## FORM 21

### Submission on the Notice of Requirement for the Rotokauri Strategic Infrastructure Designation

**Name of Submitter:** Hounsell Holdings Limited, Rotokauri Farming No3 Limited and Hamilton JV (N3) Limited

FIGURE 2 – Current Maven Associates CDP Rooding overview Plan

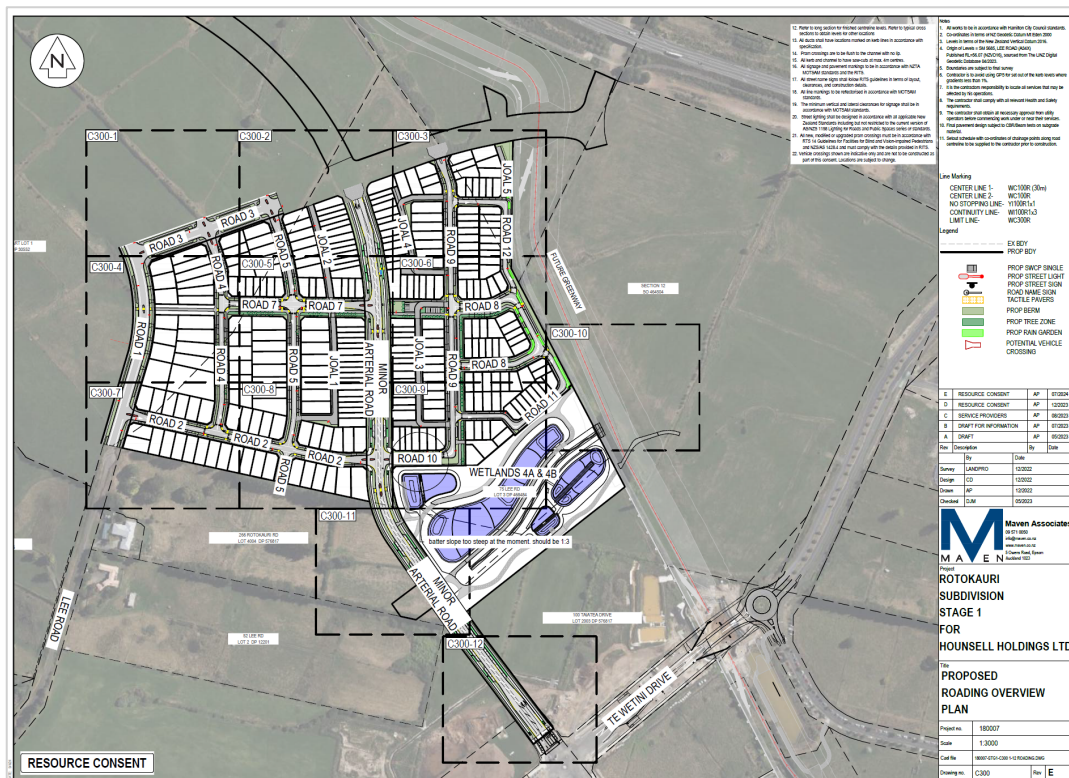
15. Furthermore, the CDP resource consent includes the design and construction of a portion of the Minor Arterial which will extend from Te Wetini Drive and Akoranga Road to Chalmers Road as indicated in Figure 2 below and artificial wetlands 4A/4B.

16. The portion of the Minor Arterial and artificial wetlands (4A/4B) located within the CDP area are currently being assessed by Hamilton City Council and will be subject to engineering plan approval and constructed and vested through the subdivision process. The consent design for the CDP including arterial and artificial wetlands 4A/4B are based off the resource consents approved through the Fast Track process (see **Attachment 3**).
17. The Minor Arterial Road design proposed within the CDP, does not align with some of the roading typology zones included in the **NoR** Application (Appendices B and J- NoR Application)-specifically Zones 1 and 8. As indicated in Figure 3 below, Zones 1 (red), 3 (yellow) and 4 (green) and 8 (light purple) apply to the Submitters site.

21. The Submitter seeks the following changes from Hamilton City Council for the Rotokauri Strategic Infrastructure Designation:
  - a) Update the **NoR** levels and alignment to reflect the levels and design approved through the Fast Track process.
  - b) Update the **NoR** road typology Zones 1 and 8 to reflect road typologies being considered through the CDP consent process.
  - c) Consistency between plans within appendices provided in support of the **NoR**.
  - d) Such further relief or consequential amendments as considered appropriate and necessary to address the matters raised above.
22. The Submitter wishes to be heard in support of this submission.
23. If others make a similar submission, the Submitter will consider presenting a joint case with them at a hearing.

FIGURE 3 – NoR Application - Appendix B – Beca Road General Arrangement

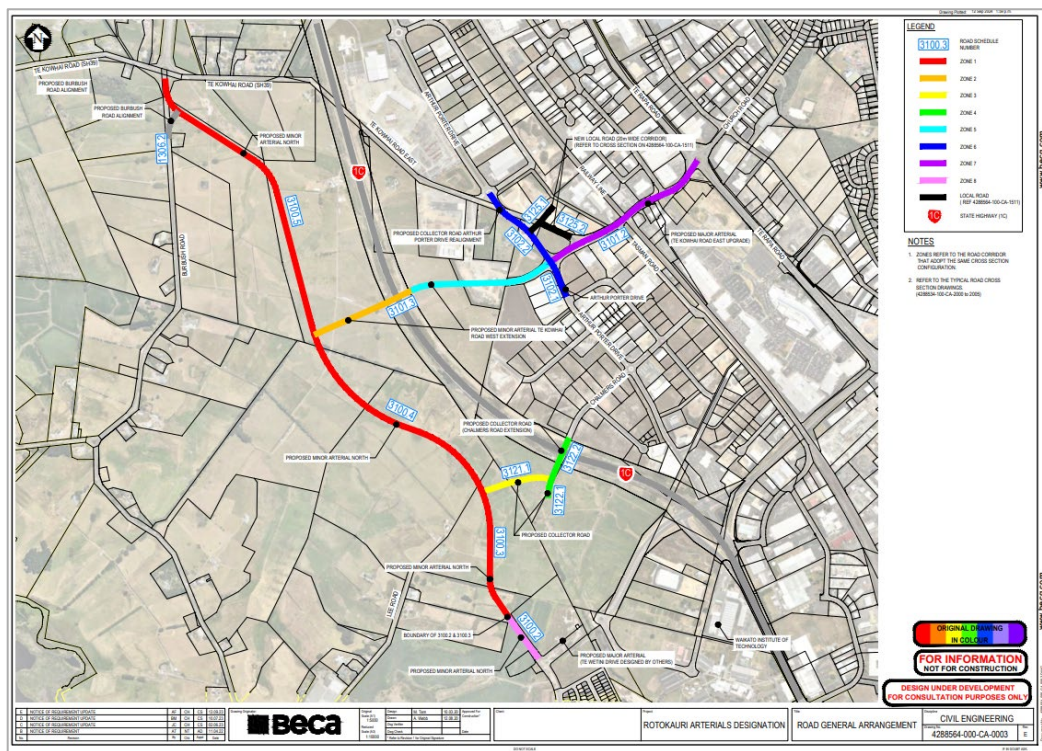
19. Furthermore, the Submitter notes there is disparity between some of the road typologies within Appendix B.2 and Appendix J of the **NoR**. Specifically, the plans for Zone 4 do not align between the appendices. The Submitter request that the plans within Appendix J align with plans within Appendix B.2 of the **NoR** (in addition to above changes re alignment with the CDP plans).

FIGURE 4 – CDP Resource Consent – Minor Arterial Road Typology Design

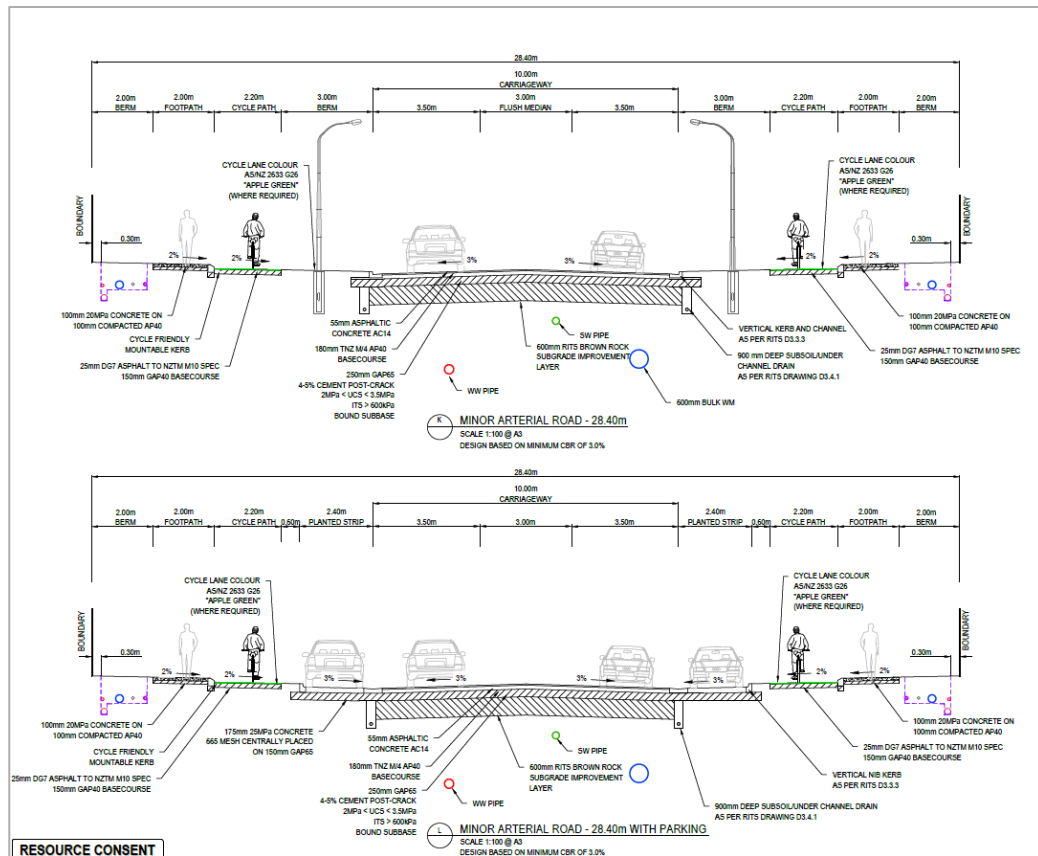
18. Road cross-section typologies for the CDP are shown in Figure 4 below. In summary the Submitter is proposing a 28.4m road width up to the Chalmers Road intersection with a 10m carriageway. The Submitter is seeking changes to these road typology zones within the **NoR** to align with those being proposed and considered within the CDP application.
